PCN: V09-094-00475504-OA

Product Change Notice

APDS-9700-020, QPDS-M901, QPDS-M906, QPDS-M910

Change of assembly site.

Figure 1: Physical inspection of the APDS-9700 between the 2 sources.

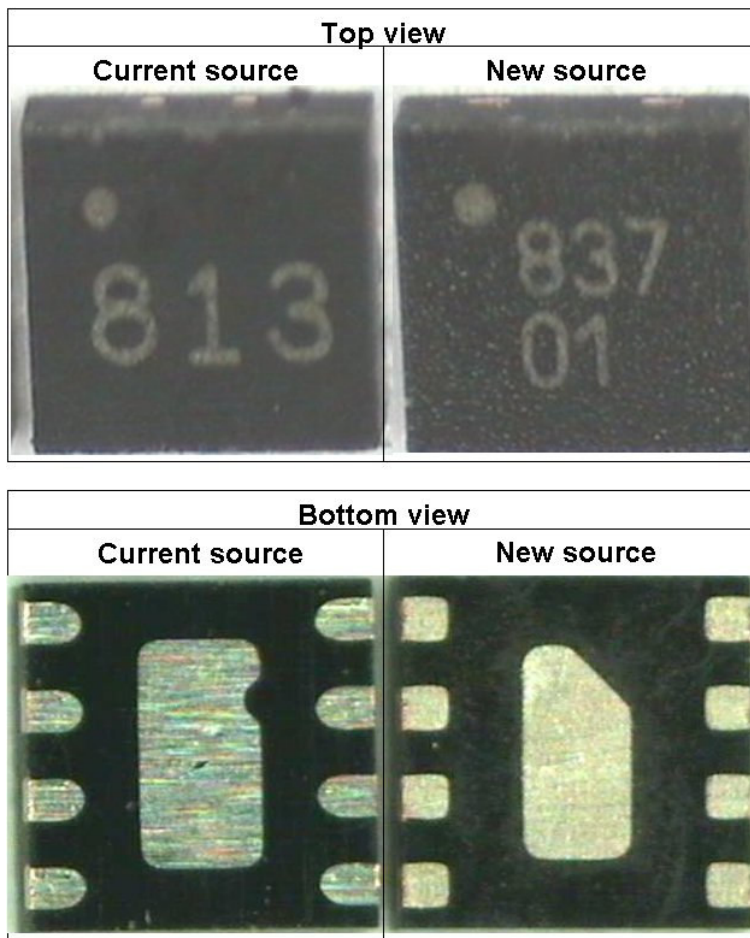
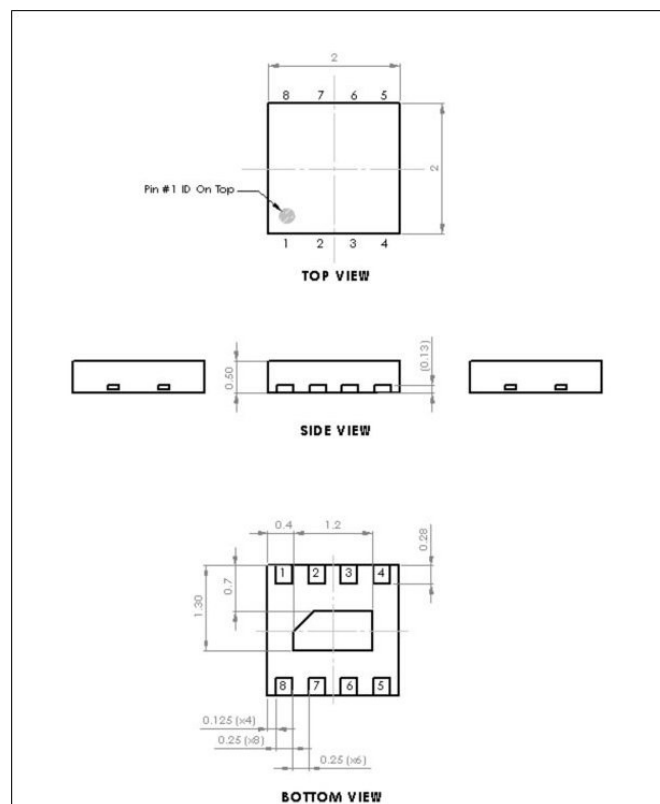
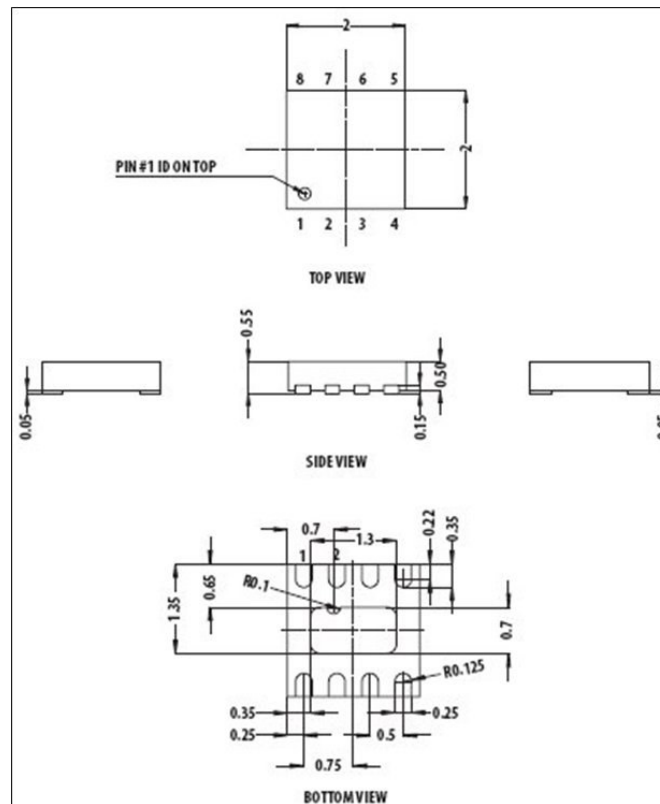
The device specification will remain the same, which will ensure product electrical performance remains the same. Pls see Fig.1 for the some subtle package outline difference between the 2 sources. Appropriate electrical characterization and reliability qualification will be performed on representative products to insure normal parametric distribution, consistent electrical performance, and reliability.

Comparison of the package outline between the current source (LHS of Fig.1) and new source (RHS of Fig.1).

- 1) Laser mark is extended to 5 characters to denote YWWLL, where Y-year, WW – workweek, and LL –lot number.
- 2) Pad size is slightly different. However, the exiting solder land pattern can be used for both packages.
